Submission:
Sandyford Clonskeagh to Charlemont Street
Pedestrian & Cyclist Improvement Scheme
(SC2C)

4.0.6 Legend Clarifications

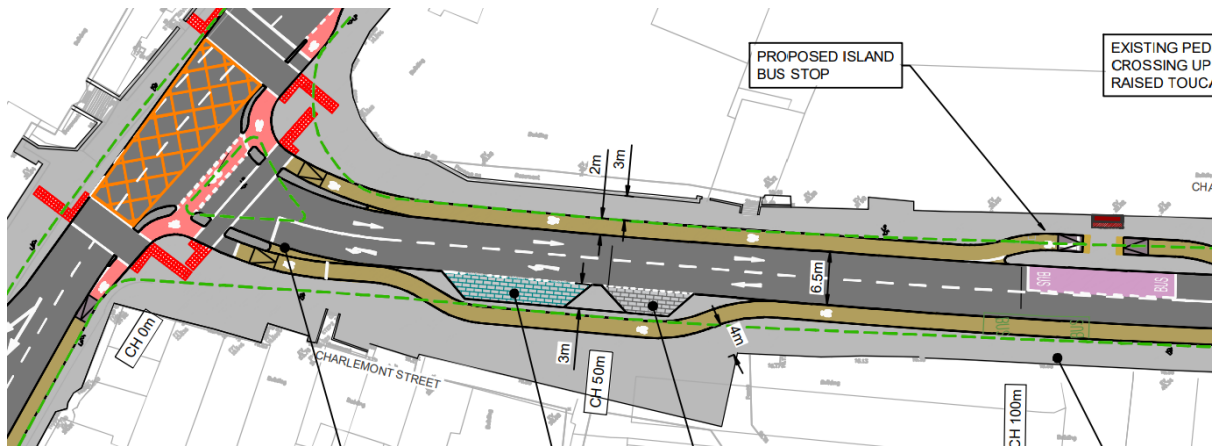
There are a number of confusing Legend items and terminology in the exhibited drawings that require further explanation:

- It appears that the legend items for tactile paving have been juxtaposed? This creates some confusion in relation to what crossings are controlled or uncontrolled?
- There is a Legend Item for 'proposed delineation surface', which appears on a number of the drawings but it is not clear what exactly it means? It is notable that not a single cross section is provided on the drawings for any of these 'proposed delineation surface' areas. This requires clarity.
- The Legend Table uses the term 'Cycle Lane', when in fact the term used should be 'Cycle Track' for any cycle route above and off road level. A 'Cycle Lane' normally refers to an onroad route at road level.
- The Legend table is missing references to the different types of crossings. Clarity needs to be given on this issue throughout the scheme.

- While appreciating that colours, representing specific features, may sometimes be distorted on screen, confusion is created in a number of areas where colours appear which are not clearly represented in the Legend, or appear to be misplaced.
- Confusion is also created in a number of the General Arrangement drawings as the arrows indicating where a cycle track drops down or up appear to be wrongly indicated in some locations? This requires clarification.

General Arrangement Drawing 1 Section

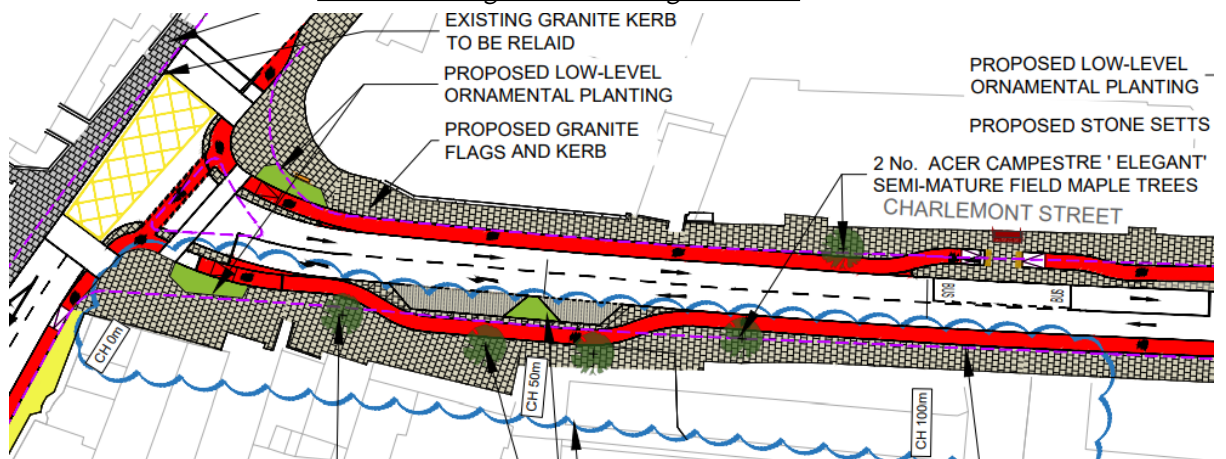
We welcome the detailed landscape plans as outlined in the Landscape Permanent Scheme drawings which are exhibited separately as a subset of the main drawings. But, the Legend Item for 'proposed landscape' on the Permanent Scheme Drawings does not match that outlined in the Landscape Permanent Scheme Drawings. This dichotomy fails to give the full picture in the Permanent Scheme Drawings, where landscape proposals can be a major factor in 'selling' the project? See below examples from both sets of drawings, outlining the difference in detail.
